# Sydney Football Stadium Redevelopment Concept Proposal Modification 5

State Significant Development Modification Assessment  
(SSD-9249-Mod-5)

**Subtitle:** Modification to amend the project boundary and building envelope to facilitate members facilities

**Figure 3 |** Proposed site boundary (Source: Modification Application, 2020)

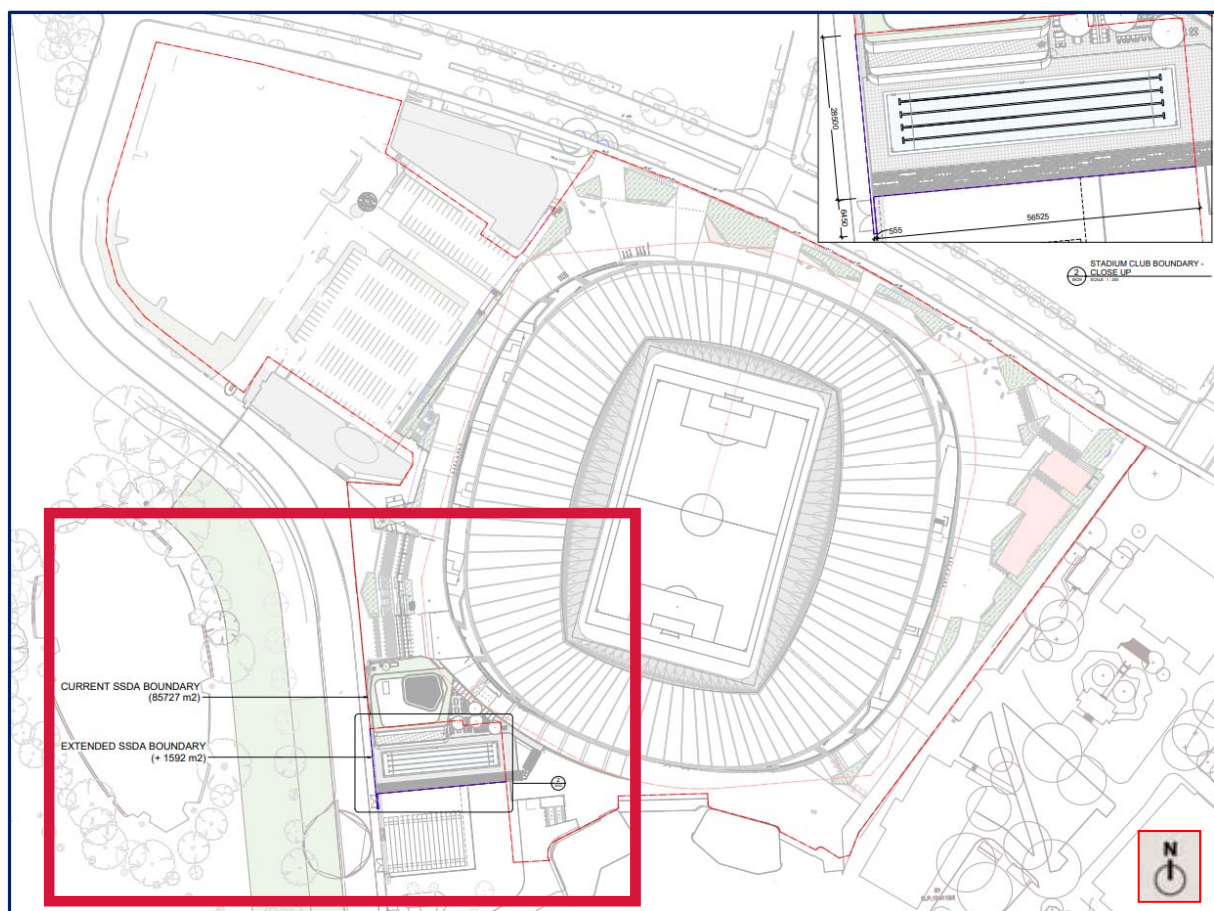
The purpose of the modification is to alter the current project boundary to include a portion of additional land (1,592sqm) within the approved boundary. This land currently comprises the Sydney Cricket Ground's (SCG) practice area, part of a tennis court located to the south-west and part of a wall running south along Driver Avenue (see **Figures 3 and 4**).

**Figure 5** | Proposed new building envelope (blue dashed line) looking east (Source: Modification Application, 2020)

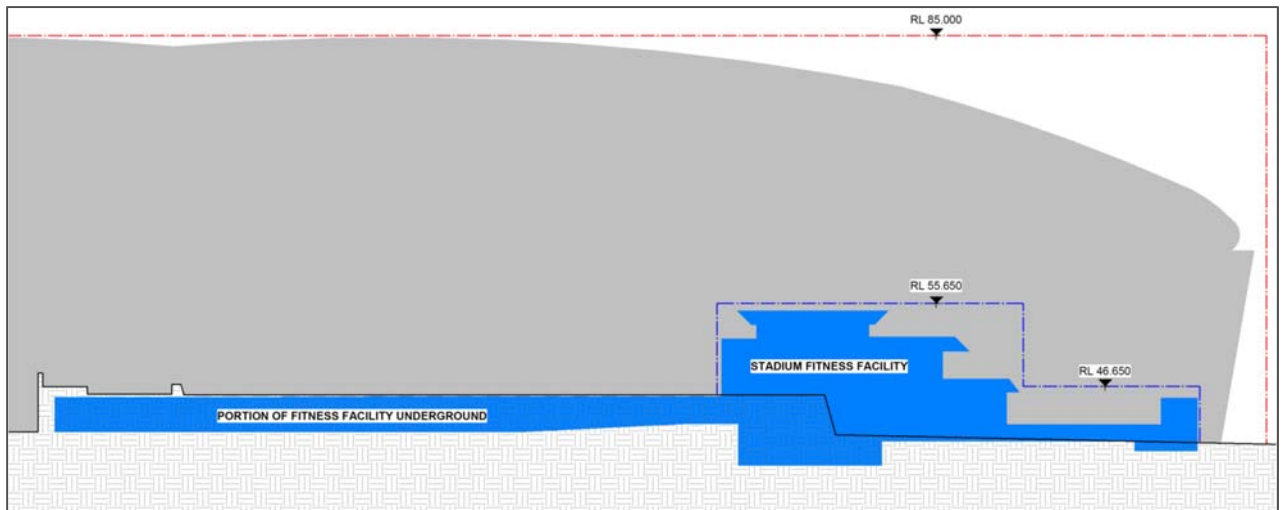
The proposed modification seeks to add a secondary building envelope (see **Figure 5**) and increase the overall footprint of the SFS redevelopment by 1,592sqm, equating to approximately 0.6 per cent more site area than what was originally approved. The SCG practice area, tennis courts and a wall along Driver Avenue would be removed as a result (under the Stage 2 approval, as amended), with the SCG cricket practice wickets not being captured within the new project boundary (see **Figure 4**).

The Department has considered the requested modification to the building envelope in the context of the overall building envelope and footprint of the stadium and considers that the increase would have minimal impact upon the overall design of the precinct. The Department considers the secondary building envelope integrates well with the main stadium and notes that there would be no change to overshadowing of public spaces as a result of the proposed modification, nor would it have significant impacts upon the adjoining SCG operations, with the SCG practice wickets remaining. The practice wicket area is utilised by players and is not typically accessed by the public and as such, the Department considers that there will be limited change in relation to the accessibility of the SCG precinct.

**Figure 6 | Proposed pedestrian access points and circulation routes (Source: RtS, 2020)**

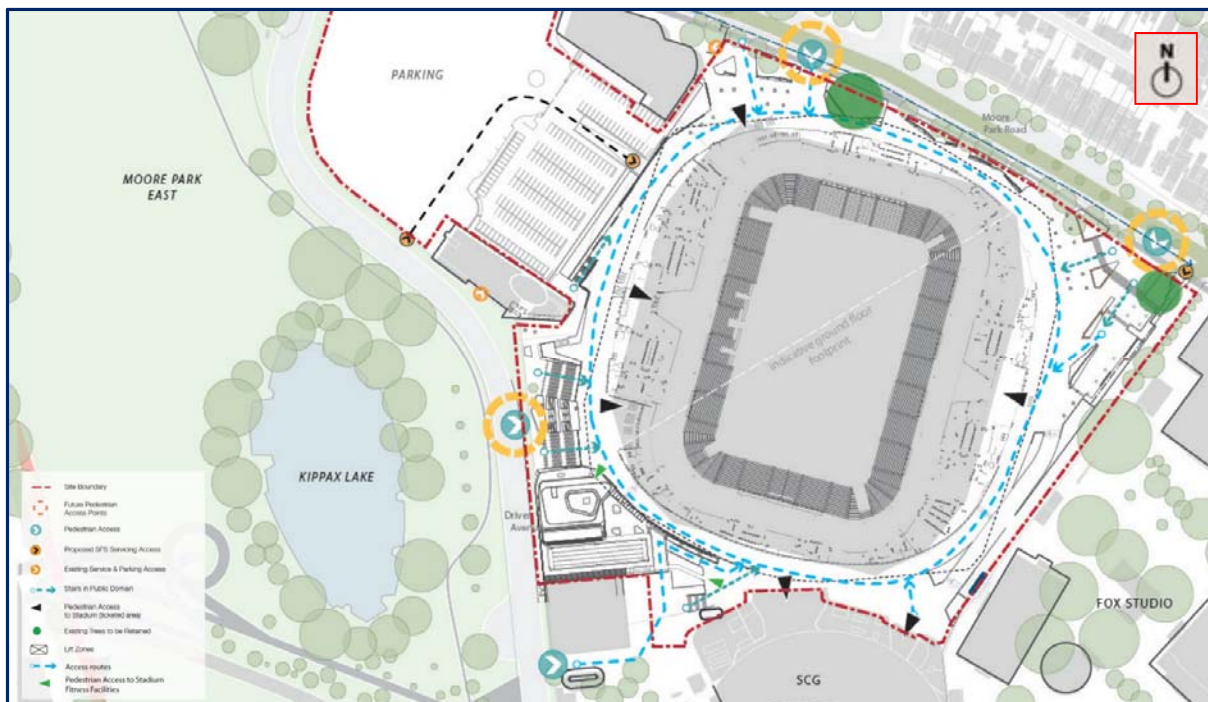
The Applicant has indicated that the proposed modification would continue to comply with the Urban Design Guidelines. The modification application also states that the proposal would not impact upon entrances to the overall stadium precinct, nor circulation pathways or public access across the site. The Applicant has indicated that the integration of the patron circulation zones would continue to integrate with the external concourse as shown in **Figure 6**.

In reviewing the revised plans submitted as part of the RtS, the Department considers that the pedestrian access and thoroughfares would remain available to the general public. The Department is supportive of the project boundary modification, noting public access and circulation routes would remain unchanged.
